### Proposed Revisions to a Standard Plans Index

Index Number: 700-090

Sheet Number (s): 4 of 5

Index Title: DYNAMIC MESSAGE SIGN WALK-IN

SHEET  
4 of 5

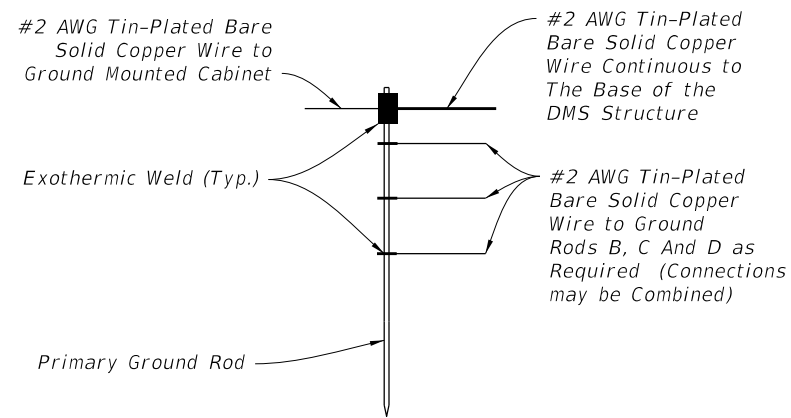
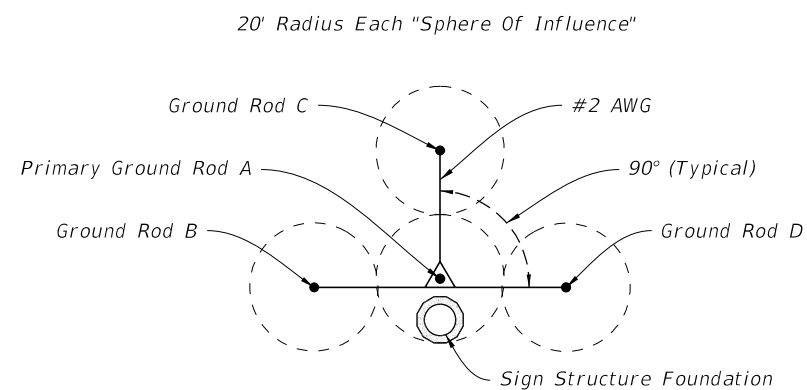
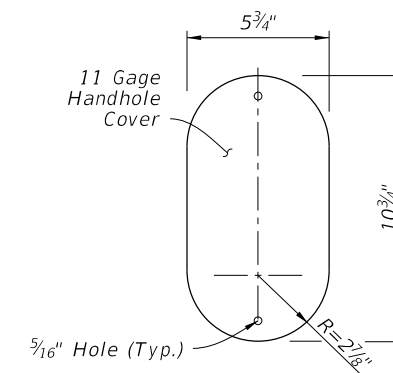
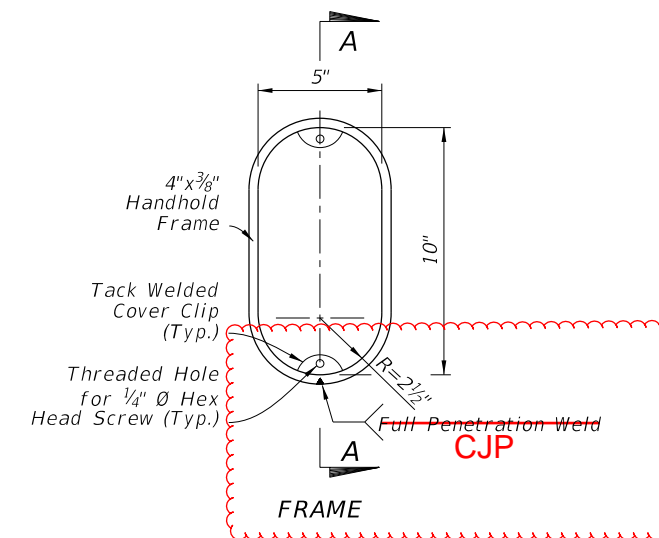
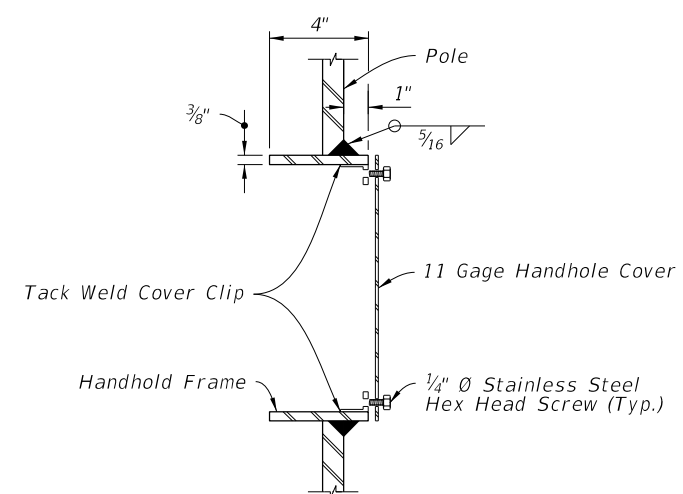
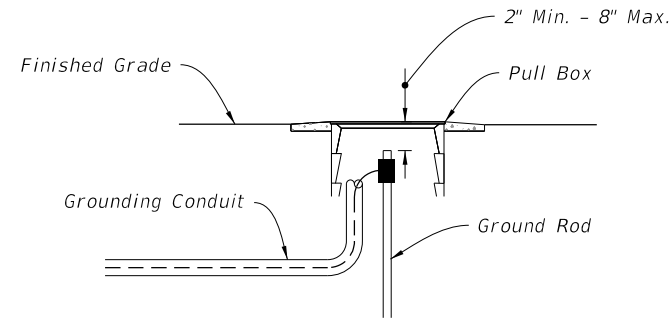
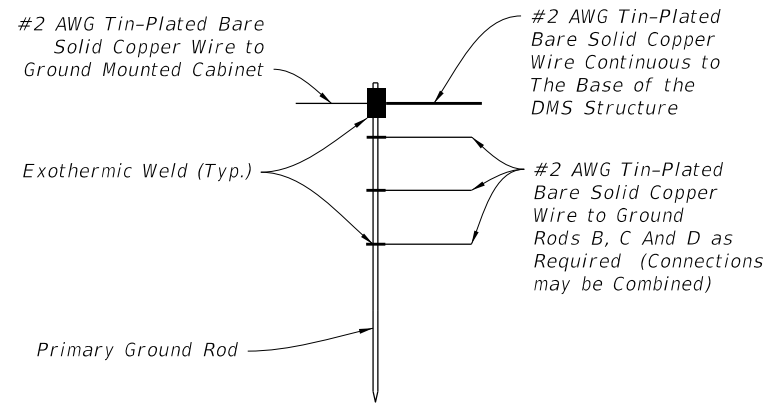
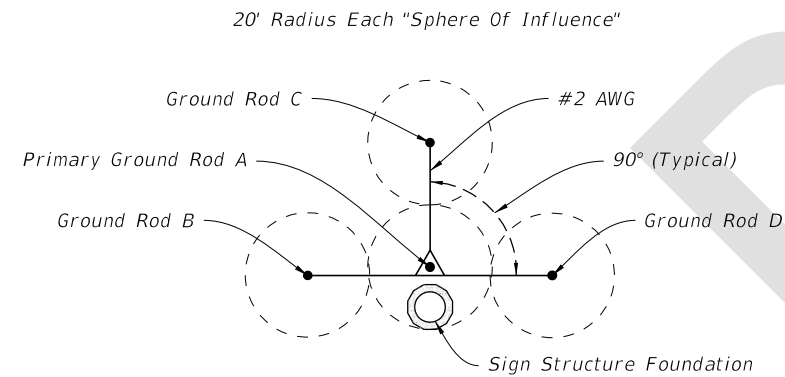
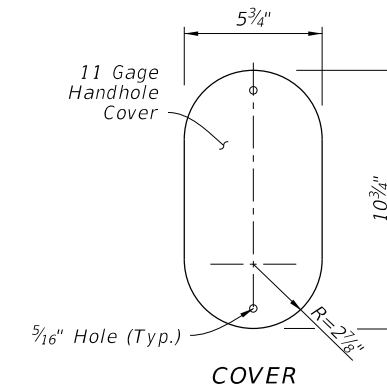
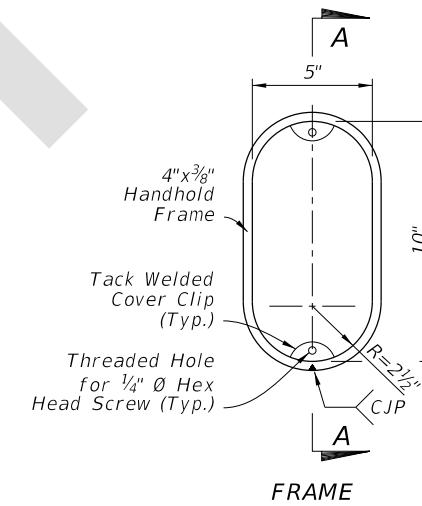
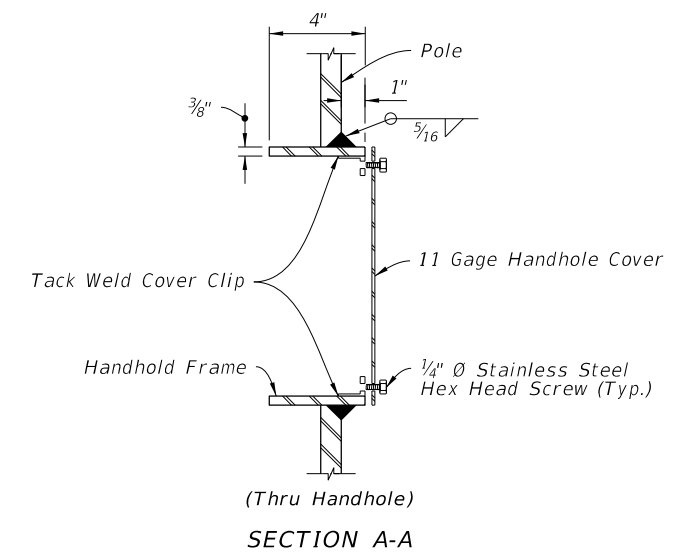
Sheet 4: Changed weld detail to say "CJP."

Sheet 4: Changing non-standard language to standard language consistent with AWS.
